DATE: May 31, 2024

TO: Planning Commission

FROM: Comprehensive and Neighborhood Planning Committee

SUBJECT: River Balcony Master Plan Proposed Addendum – Basis of Design Report

OVERALL SITE PLAN

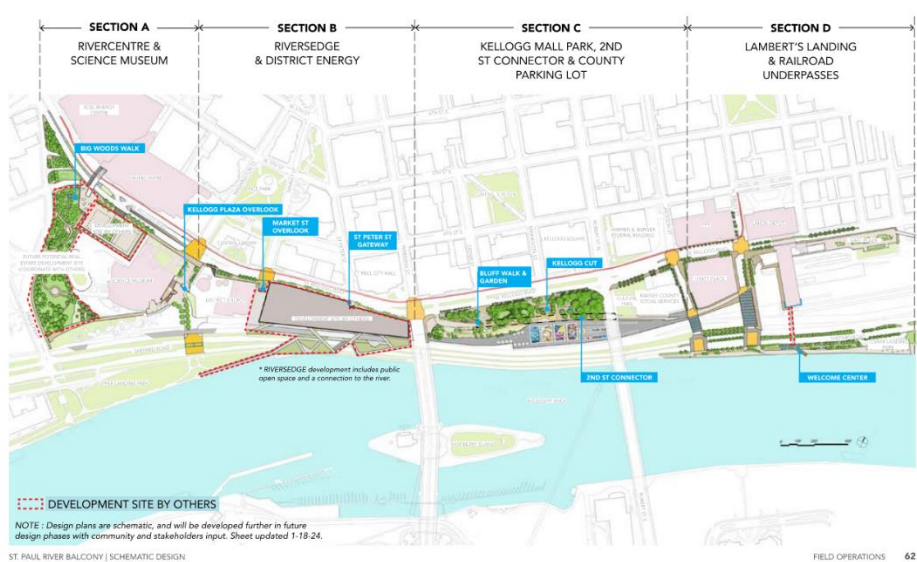
Discussion of the master plan falls into three districts – East, Central, and West. The elements of each of the districts are discussed below in items 1-22 and identify what the master plan calls for and what the basis of design report shows. Note, the basis of design report discusses the elements of the master plan according to four sections, not three districts: Section A – RiverCentre & Science Museum; Section B – RiversEdge & District Energy; Section C – Kellogg Mall Park, 2nd Street Connector & County Parking Lot (Interim improvements); and Section D - Lambert’s Landing & Railroad Underpasses. The Four Sections of the basis of design report are shown below.

KELLOGG CUT AT MINNESOTA ST

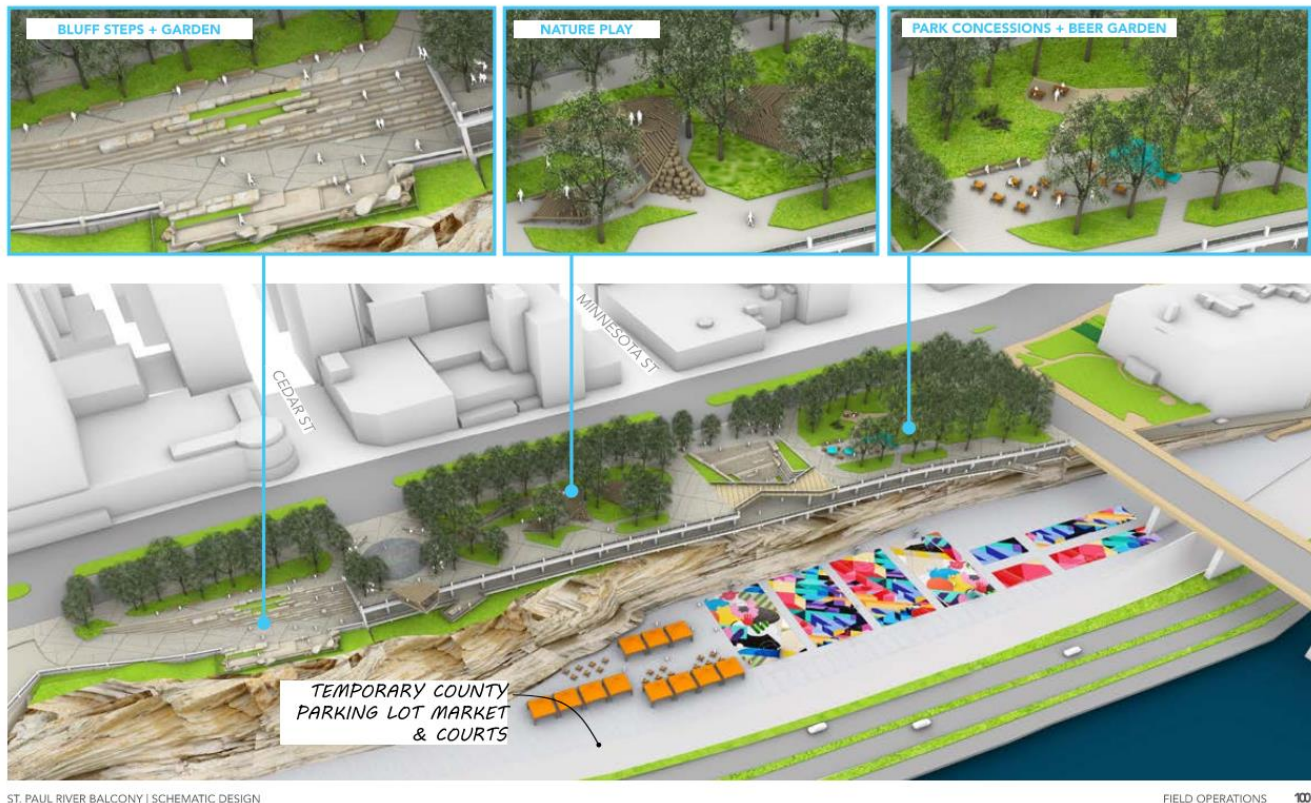
9. Balcony along south edge of Kellogg Mall Park: Kellogg Mall Park will become the central focus for city-wide events and neighborhood activities along the River Balcony. To recapture the Mississippi River as an important aspect of the overall experience of Kellogg Mall Park, the River Balcony railing will be transparent with extended platforms to allow walkers to move beyond the existing bluff and look back to the last remaining segment of natural face of the bluff.

Basis of Design Report: Kellogg Mall Park remains a central focus of the River Balcony including a feature referred to as the Kellogg Cut at the terminus of Minnesota Street. The Kellogg Cut cuts into the park to create an access down to 2nd Street. The design also includes an extended overlook at the terminus of Cedar Street to look back at the natural bluff face.
